Written Representation
for the
Royal Society for the Protection of Birds
Comments on selected Deadline 3 and Deadline 4 submissions

Submitted for Deadline 5

**Application by Hornsea Project Four Limited for an Order
Granting Development Consent for the Hornsea Project Four Offshore Wind
Farm**

Planning Inspectorate Ref: EN010098

Fig. 2. Core colony distributions (50% kernel density contour outlines) of common guillemots and razorbills during post-breeding moult (16 August–15 September). Colony locations are depicted by triangles, with colours matching the distributions

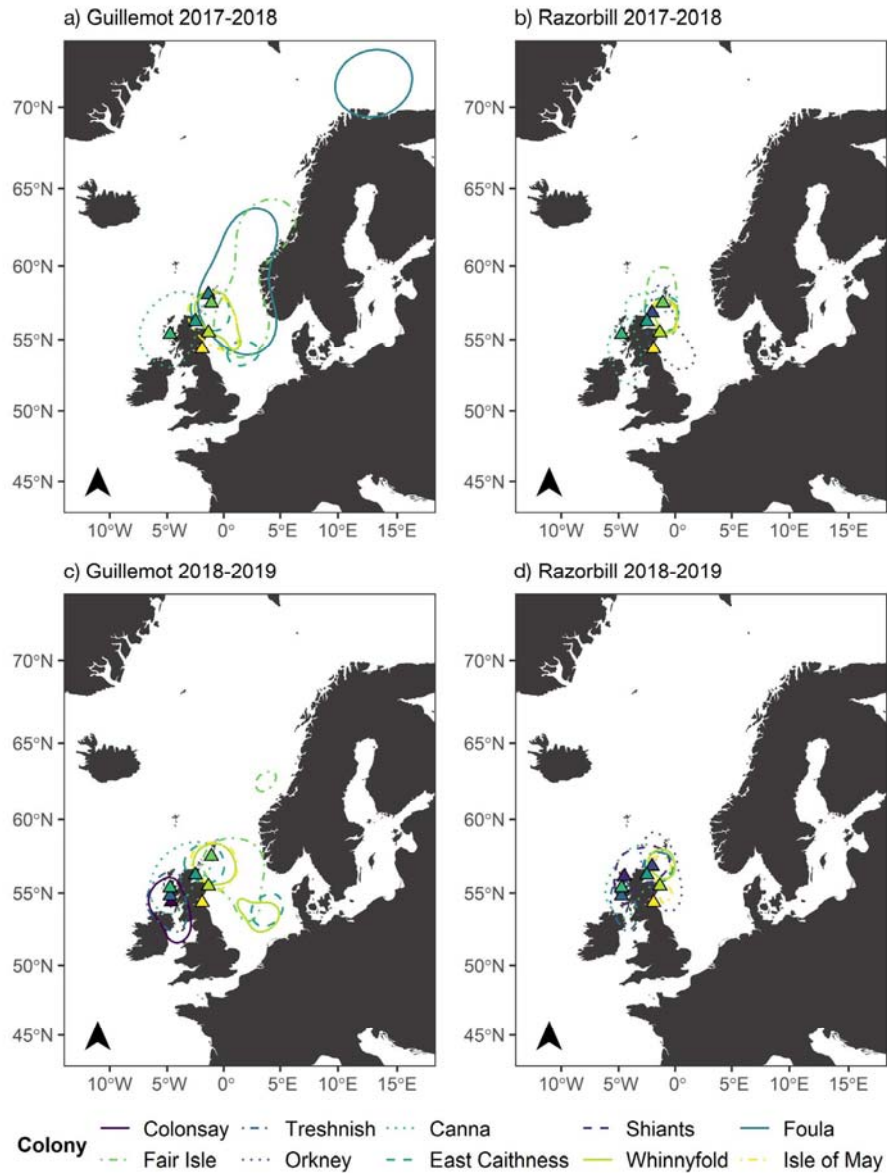
- 3.16. Furthermore, the Applicant claims birds from several colonies winter in the English Channel and this is again to overstate the evidence. Guillemot from Canna on the west coast of Scotland, and razorbill from Whinnyfold in Aberdeenshire were recorded in the English Channel. Guillemot from Treshnish islands, on the Scottish west coast, were present in the Celtic Sea in the winter. However, no guillemot from East coast colonies were recorded in the Channel Islands.

- 3.17. Indeed, the data from guillemot show that the east coast birds tend to remain relatively close to and directly east of the source breeding colony during both the post-breeding moult and winter periods. This fits with evidence that, at some colonies, birds will continue to attend the colony in the winter (Harris and Wanless, 2016⁸). As such we would expect the majority of guillemot from the Flamborough and Filey Coast SPA to remain in the North Sea east of the colony rather than moving south, and this is borne out by the high density of birds seen in the moulting period in the Hornsea 4 footprint. Razorbill do not show this tendency for colony distinct winter distribution, instead aggregating in the middle of the North Sea.

- 3.18. To clarify these points we reproduce the maps of kernel densities from Buckingham *et al.*, (2022) below. These show the core distributions of birds from the colonies where tagging took place in the period of post breeding moult (Figure 2) and the winter (Figure 3). It should also be noted that during Issue Specific Hearing 6, the Applicant's consultant considered that this paper "is not considered to be a reliable source for assessment purposes for this project."
